1. Type of Well				NMNM87877X	
Oil Well Gas Well Other			8. Well Name and No. SOUTH JUSTIS UNIT #C-22		
2. Name of Operator LEGACY RES	SERVES OPERATING LP			9. API Well No. 30-025-22906	
3a. Address PO BOX 10848 MIDLAND, TX 79702	31	o. Phone No. (include area co 432-689-5200	ode)	10. Field and Pool or E JUSTIS-BLINEBF	xploratory Area RY-TUBB-DRINKARD

PLUG AND ABANDONMENT PROCEDURE

South Justis Unit # C-22

Permanent Abandonment of Federal Wells Conditions of Approval

CURRENT WELLBORE SKETCH

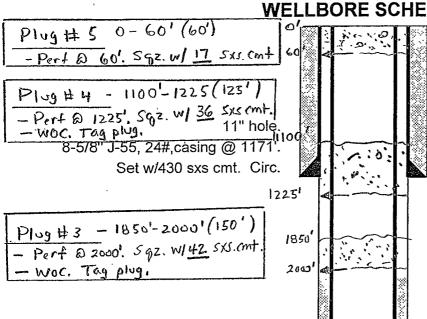
2. RIH w/ tbg. Tag Plug #1 to verify. (Plug #1: 35' cement cap at 4965' on top of CIBP at 5000') Extend to cover top of Glorietta to 4700

5. Perforate 5 ½"casing at 2000' 72 00

2200 - 2080 6. Plug #3 (Casing Plug) - Squeeze 42 sxs Class C cmt from 1850-20002 (4502). WOC. Tag plug.

7. Perforate 5 ½" casing at 1225- 1300 1300-1121

TOC @ 2040'TS. **2/35**
